Certified Action of the City of Raleigh Planning Commission

Case File / Name: SP-21-10/ Cheviot Assemblage Lots 6 & 7

SP-21-10 Cheviot Assemblage Lots 6 & 7 – Site plan

Staff Report

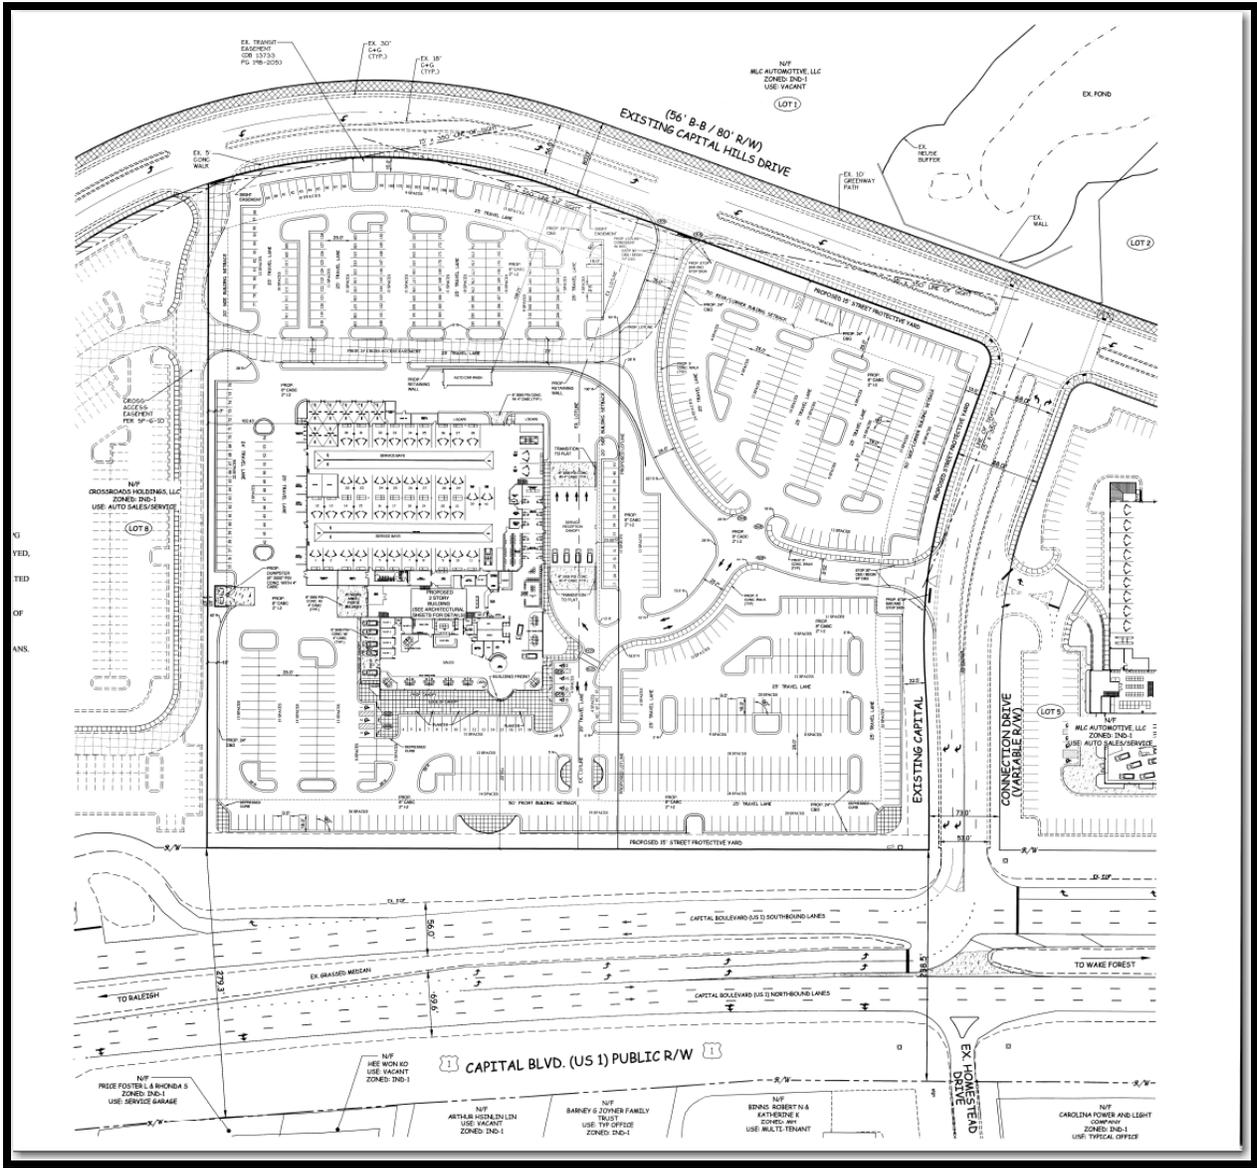
<u>Comment</u>	<u>Response</u>
The committee recommends that the building be designed “in the round”, with all building facades exhibiting a like degree of detail and quality of materials as that facing Capital Boulevard.	The proposed building is the result of intense coordination between the developer of the site and representatives of the dealership. Features have been incorporated into the design to break up building mass, vary the architectural materials, and provide tasteful use of color for architectural interest—all within the parameters imposed by the dealership brand. We are proud of the building and the investment in the City that it represents. We respectfully request approval of the plan as submitted.
As was recommended for recent site plans on Cheviot Assemblage Lots 5 and 8, install a means of dimming pole-mounted lights after regular business hours, to reduce reflective upright and glare.	The Owner has considered the request of the Appearance Commission regarding the dimming of the parking and display lights after the close of business. Although the Owner sees the potential economic and aesthetic merit of maintaining a lower level of lighting during after business hours as compared to the levels required during business hours, the owner has concerns that reduced lighting levels could result in a lower level of security for the tremendous value of investment associated with maintaining the necessary inventory of automobiles. The proposed lighting plan meets all requirements of the City’s lighting ordinance, and our request is that the plan be approved as submitted

Install additional planting islands along the unbroken stretch of parking lot curbing facing Capitol Boulevard, to provide visual relief and reduce “heat island” effects.	The Owner has considered the request of the Appearance Commission related to installation of additional landscape islands along the frontage of Capital Blvd. Although the parking configuration and associated landscaping as submitted is in conformity to the City’s ordinances and standards, an additional landscape island occupied by evergreen shrubs has been added to the plan to break up the longest row of continuous parking spaces.
